JP Research review of JASIC & BAST Flex-PLI Injury Reduction Estimate

GTR09 PH2 Informal Working Group

March 18th to 20th, 2013

Figure 1. Percentage of Serious Lower Limb Injuries* that are Tibia Fractures

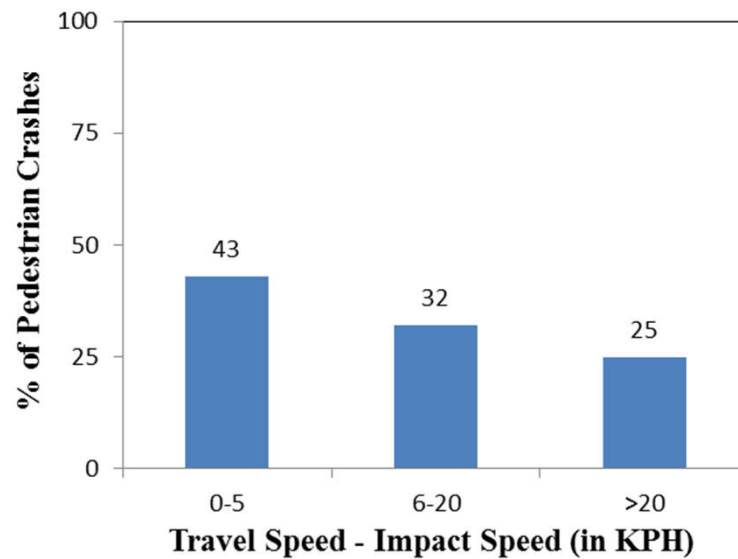
- JASIC used a factor of 66% to convert “Serious Lower Extremity Injuries” to “serious Tibia Injuries” (GTR9-5-14) . JPR’s analysis showed that this approach results is an over estimate of Tibia injuries.
 - JPR found 121 serious lower extremity injuries in the PCDC (MAIS2+, excluding fatalities), 75 (62%) were Tibia fractures and the % varies significantly across the impact speed, see figure-1 below.

- Because of the small sample size of PCDS it’s difficult to estimate an average conversion factor similar to the JASIC study. However, the Injury distribution versus speed, figure-1, can be used to check the potential tibia injury numbers.
- If the PCDS speed category distribution is used with the data in GTR-5-14 the serious tibia injuries would be 30% lower than the JASIC estimate.

Figure 2. Percentage of Pedestrian Crashes by Difference between Travel Speed and Impact Speed

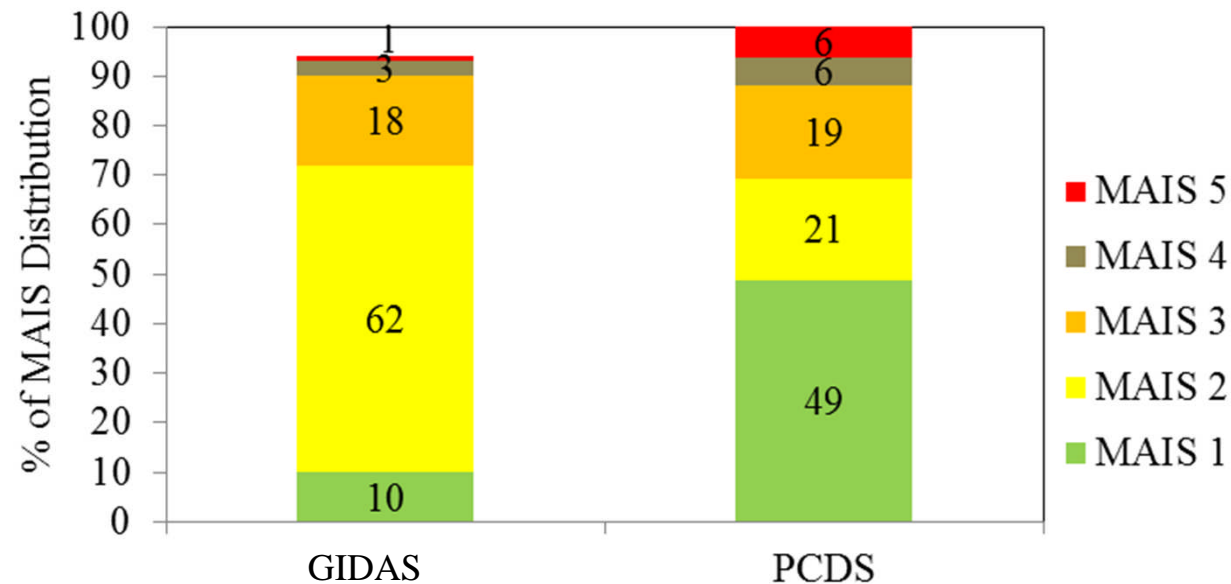
- Impact speed is an important contributor to injury severity for pedestrians interacting with motor vehicles.
- The PCDS data was used to identify the distribution of impact speeds for pedestrian accidents
 - Figure 2: Only 43% of the crashes show up to a 5KPH difference between impact speed and travel speed
 - Thus using the “Travel speed – 5KPH” to estimate the pedestrian impact speed is not a valid approach to estimating the number of serious tibia injuries

- JASIC's assumption of the relationship between travel speed and impact speed (*Impact speed = Travel Speed – 5KPH*) cannot be used in general. As seen in the PCDS data only ~43% of the accident have a 5KPH difference between travel speed and estimated impact speed.
